Site Accessibility Evaluation

F. W. Kent Park

**2048 US-6
Oxford, IA 52322**

Inspection Date: 10/23/2018

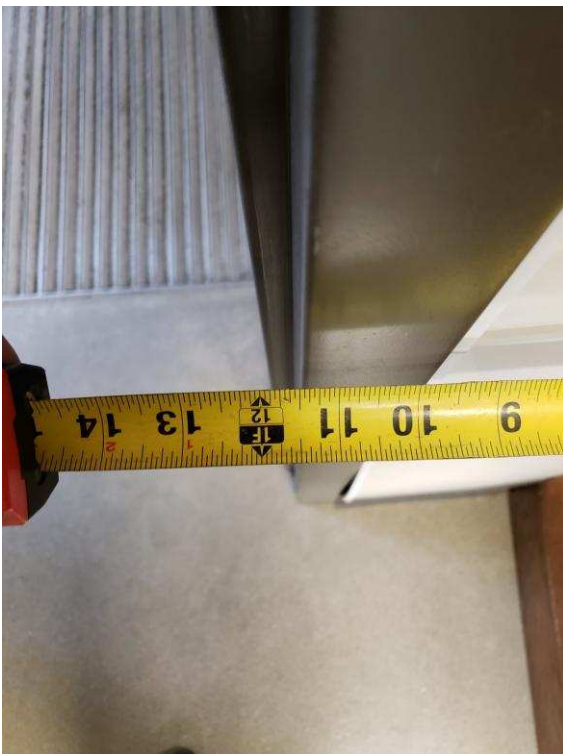
conservation program manager- 14#; desk 12" on pull

For all doors along the public circulation route, provide required maneuvering clearance on push and pull side of doors

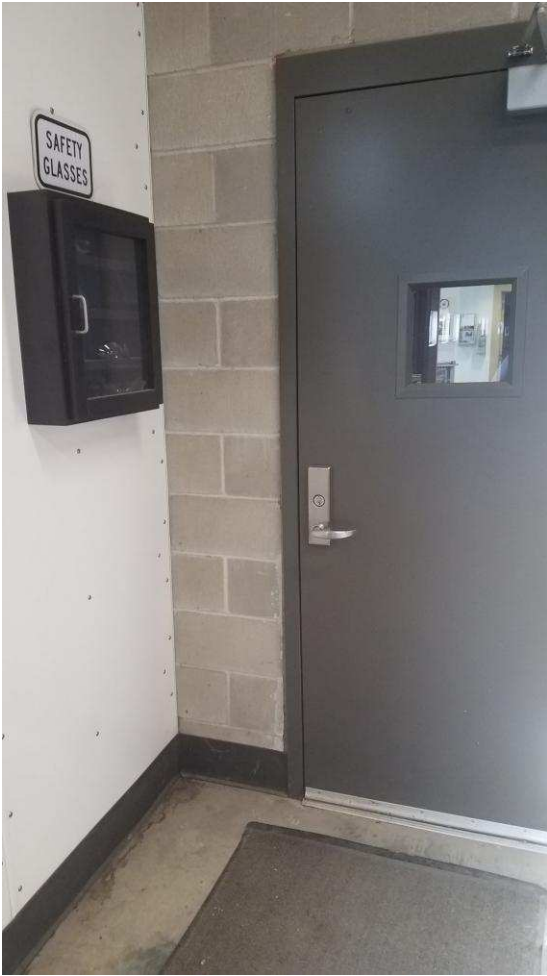
shop from lobby - window high, recessed push side, cabinet in pull side clearance, push force 14#, closes fast

For all doors along the public circulation route, provide required maneuvering clearance on push and pull side of doors

For all doors along the public circulation route, inspect, adjust, and maintain 5 lbf to open interior doors

For all doors along the public circulation route, replace doors with ones having sidelight viewing windows max 43" aff

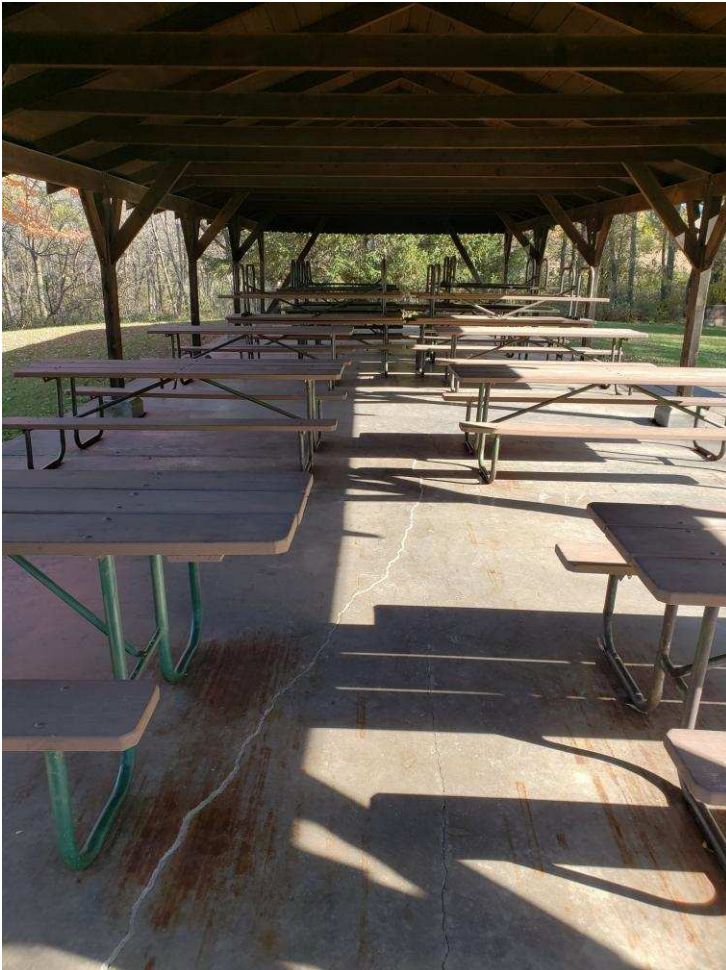
Picnic tables shall provide at least one wheelchair space for each 24 linear feet (7320 mm) of usable table surface perimeter. Wheelchair spaces shall be 30 inches (760 mm) minimum by 48 inches (1220 mm) minimum. Wheelchair spaces shall be positioned for a forward approach to the table and provide knee and toe clearance complying with 306 under the table

Replace picnic table with one of an accessible design as a smart practice

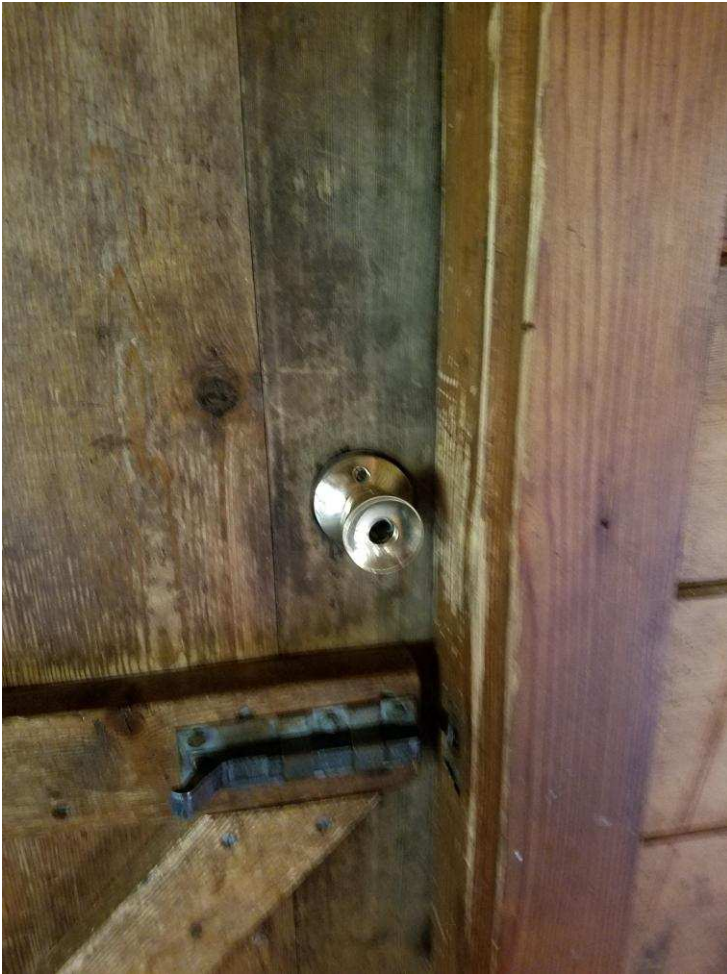
Yth lodge, back exit -
knob, fast, 12#, 2" CIL

For all doors along the public circulation route, provide required maneuvering clearance on push and pull side of doors; repair or bevel CIL at doorway to max .25"

For all doors along the public circulation route, inspect, adjust, and maintain closing speed on door closers

Replace hardware with lever hardware or hardware operable without a tight pinch or grasp

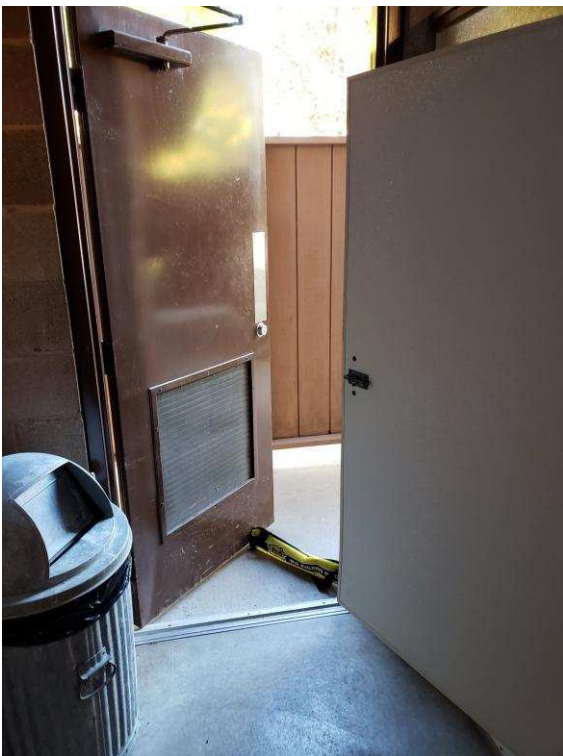
stall door and
garbage in clearance,
14# push

For all doors along the public circulation route, provide required maneuvering clearance on push and pull side of doors

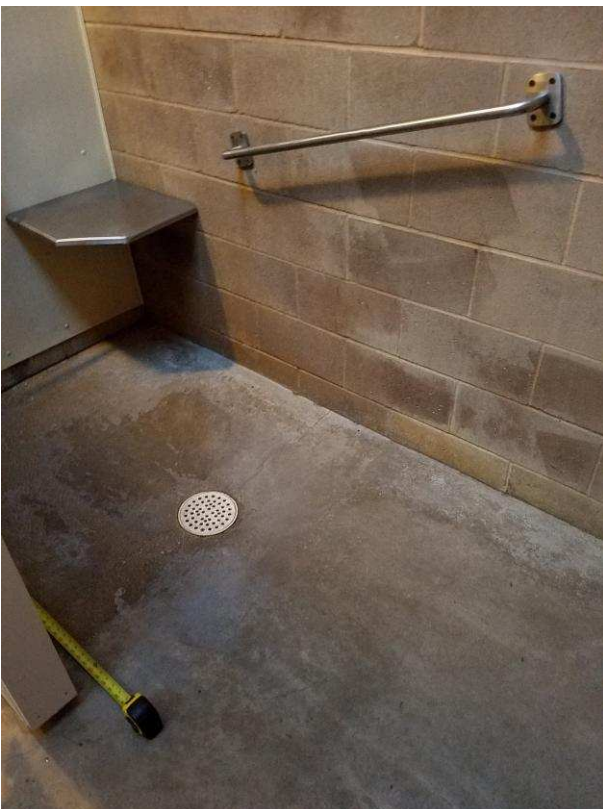
Transfer type shower compartments shall be 36 inches (915 mm) by 36 inches (915 mm) clear inside dimensions measured at the center points of opposing sides and shall have a 36 inch (915 mm) wide minimum entry on the face of the shower compartment. Clearance of 36 inches (915 mm) wide minimum by 48 inches (1220 mm) long minimum measured from the control wall shall be provided.

Provide appropriate CFS on the exterior of the transfer shower

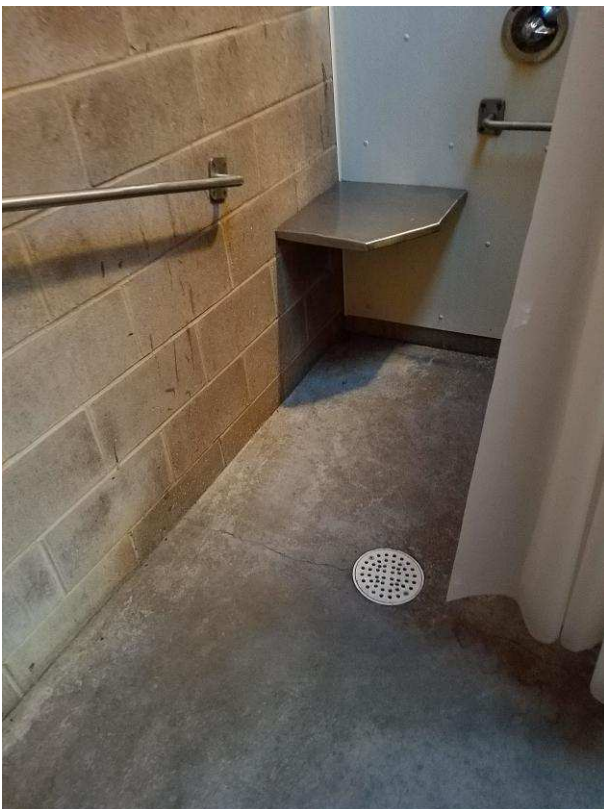
Transfer type shower compartments shall be 36 inches (915 mm) by 36 inches (915 mm) clear inside dimensions measured at the center points of opposing sides and shall have a 36 inch (915 mm) wide minimum entry on the face of the shower compartment. Clearance of 36 inches (915 mm) wide minimum by 48 inches (1220 mm) long minimum measured from the control wall shall be provided.

Provide appropriate CFS on the exterior of the transfer shower

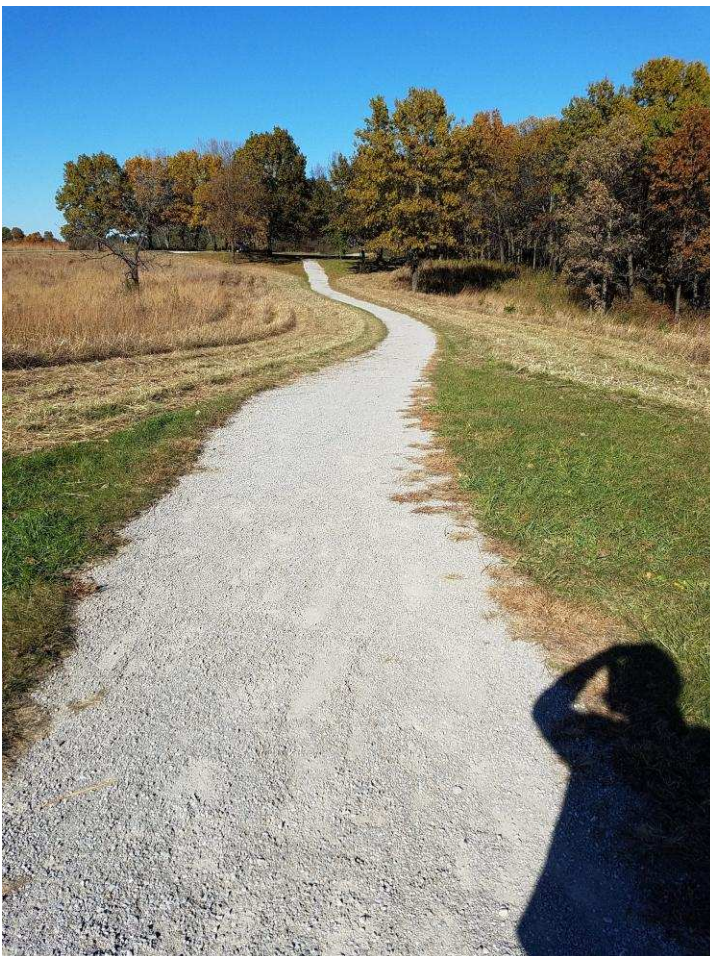
loose stone, slopes
off at sides, debris on
trail

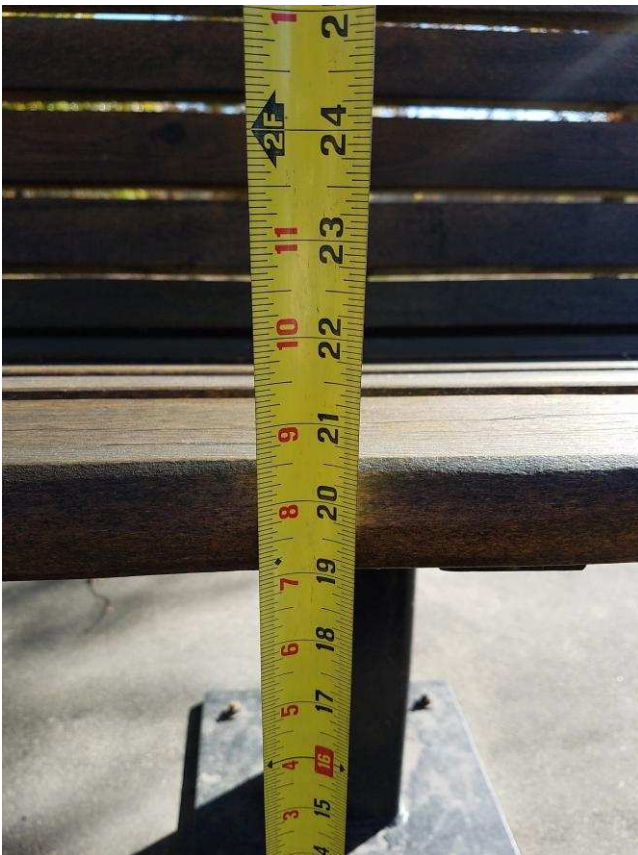
bench at Valley view prairie, 20.5", no AR

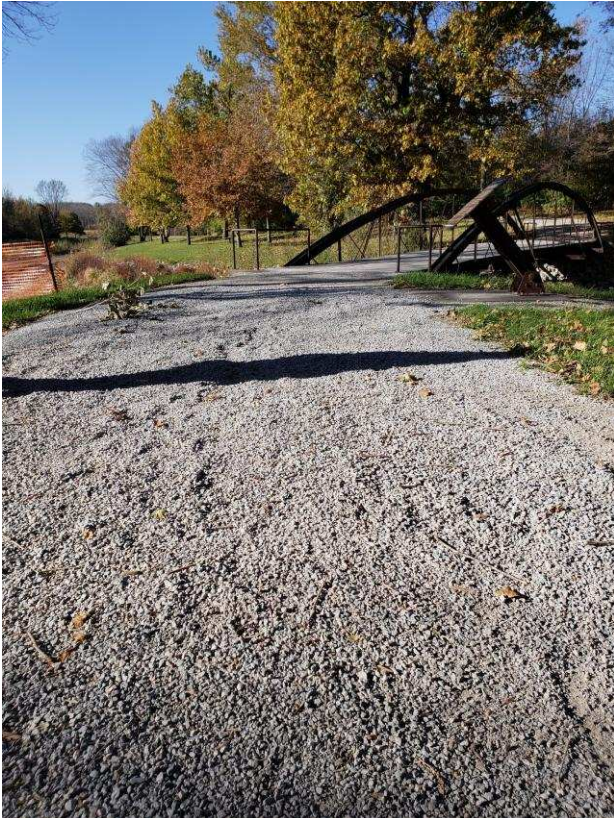
Dunlap entry- gravel to bridge loose and unstable, rocks larger; surface requires general maintenance and upkeep
